INTERIM CHANGE NOTICES (ICN) FOR RESOURCE CONSERVATION AND RECOVERY ACT (RCRA) GROUNDWATER (GW) MONITORING PLANS

Attached please find ICNs for seven GW monitoring plans, for your information. The following table summarizes the attached ICNs:

INTERIM CHANGE NOTICE  
(ICN)

ICN - PNNL-11523 R0.1

**Figure 3.1.** Facility Layout and Locations of Monitoring Wells for the 216-B-3 Pond System.

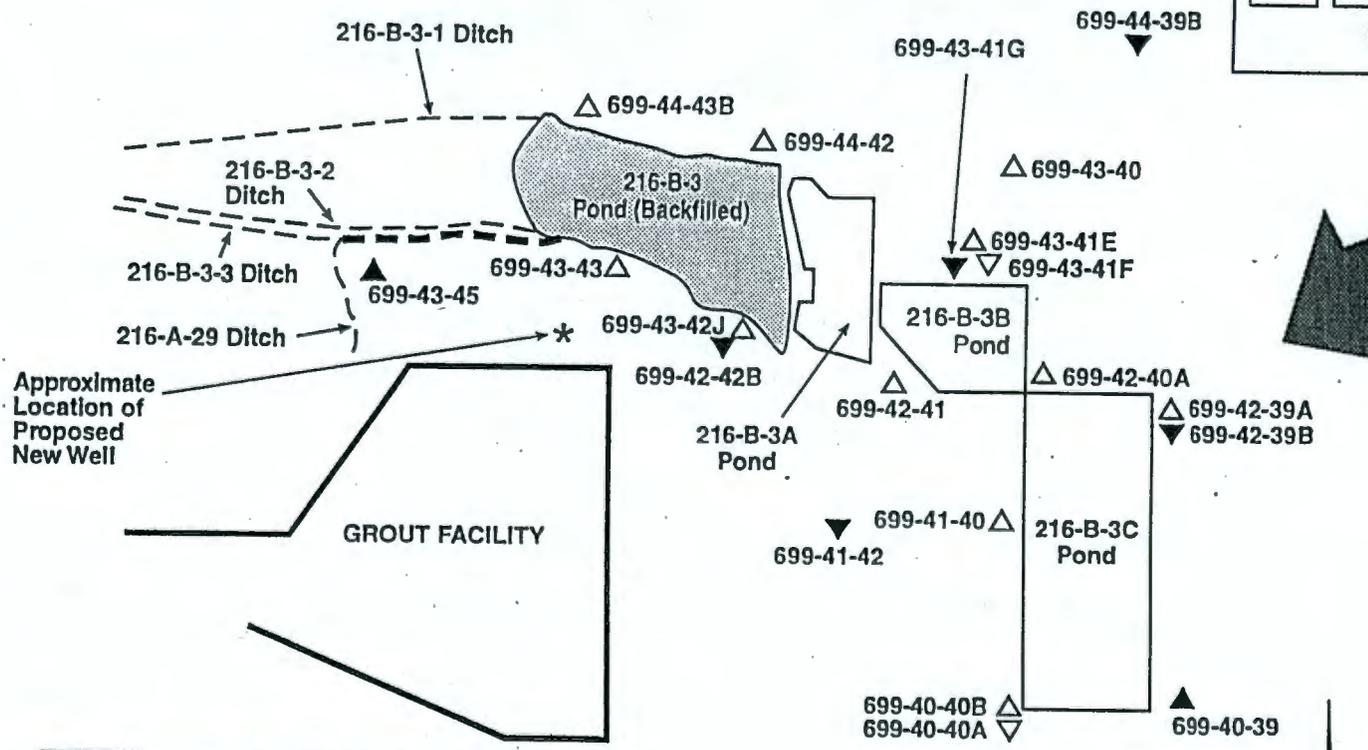
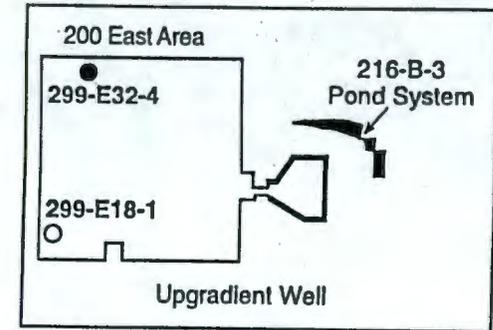
The existing array of wells around the B Pond System provide more than an adequate number of potential monitoring points from which to select. The possible exception is the area immediately southwest of the B Pond, for which a new well is proposed. The revised well network is shown in Figure 3.1. In all, 9 wells (8 downgradient) are proposed for the revised network.

A comparison of these well locations with the June 1998 potentiometric surface is shown in Figure 3.2. Well 299-E32-4, in the northwest portion of the 200 East Area, will remain as the upgradient monitoring location.

The potential sources of groundwater contamination from the facility and groundwater flow directions (see discussion in Section 3.4.2), indicate that additional monitoring coverage is needed immediately southwest of the main pond. Hence, a RCRA-compliant, downgradient well is proposed for the location shown in Figure 3.1. The well will be screened over an extended interval to accommodate rapidly falling water levels and lengthen the service life of the well, and to intercept contamination at different levels in the aquifer. The well will be drilled to basalt (base of the uppermost aquifer) and screened below the water table. Upon completion, the well will be sampled for the Appendix IX list of constituents, and thereafter for the list of parameters shown in Table 11.
